**ADDENDUM 02**  
**FOR**  
**2024 WHITE PINE STREET & UTILITY PROJECT**  
**VILLAGE OF BUFFALO GROVE, IL**  
**VoBG 2024-02**

Date of Addendum: Friday, November 10, 2023  
Bid Due Date: **10:00 AM Thursday, November 16, 2023**

**Description of Addendum:**

STORM SEWER MANHOLE LID  
DETAIL

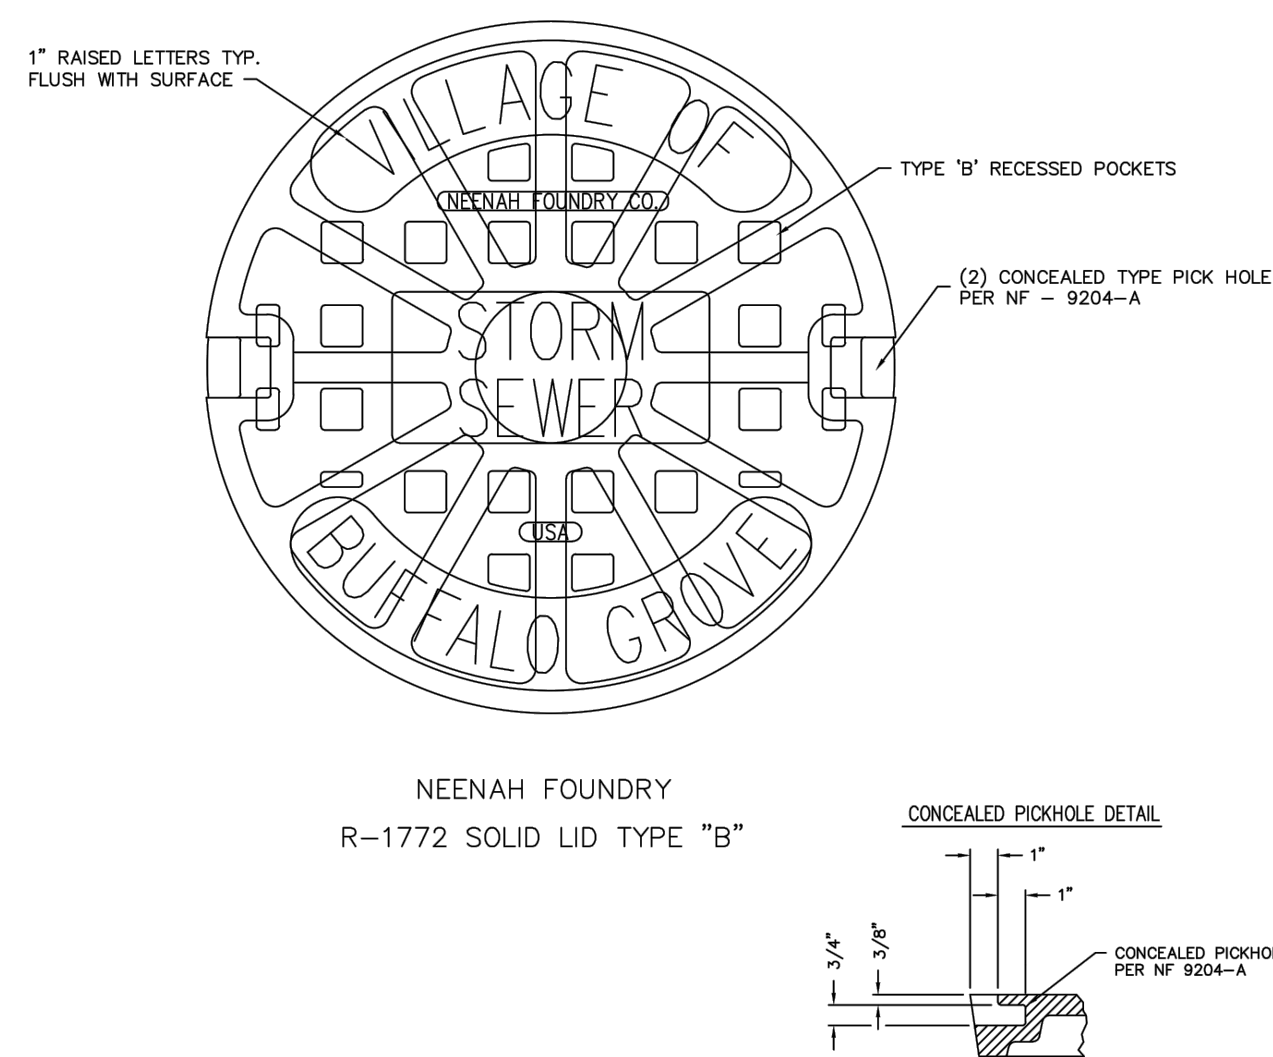
**Frames and Lids, Type 1, Closed Lid (Storm) (Special)**

This work shall include all labor, material, and equipment necessary to furnish and install frames and lids, of the type specified, at locations shown on the Engineering plans in accordance with Section 604 of the Standard Specifications and as specified herein.

The structure shall be brought flush to the surrounding elevation with new adjustment rings. Adjustment ring material type and method shall be in accordance with Exhibit No. 109 Materials List, as specified herein. Bricks, aggregate, lathe, or any other organic material shall not be used as shim materials or otherwise.

The lid shall be cast iron with the word 'Storm' imprinted and embossed with 'Village of Buffalo Grove, in accordance with Section 604 of the Standard Specifications.

The existing frame and lid shall be salvaged and delivered to the Village of Buffalo Grove Public Works yard or at a location determined by the Village. Any material not suitable for salvage shall be disposed of off-site according to Article 202.03 of the Standard Specifications.

This work will be measured in place and paid for at the contract unit price per each (EA) for FRAMES AND LIDS, of the type specified, (STORM), (SPECIAL) which price shall include all labor, material, and equipment required to complete the work as specified herein.
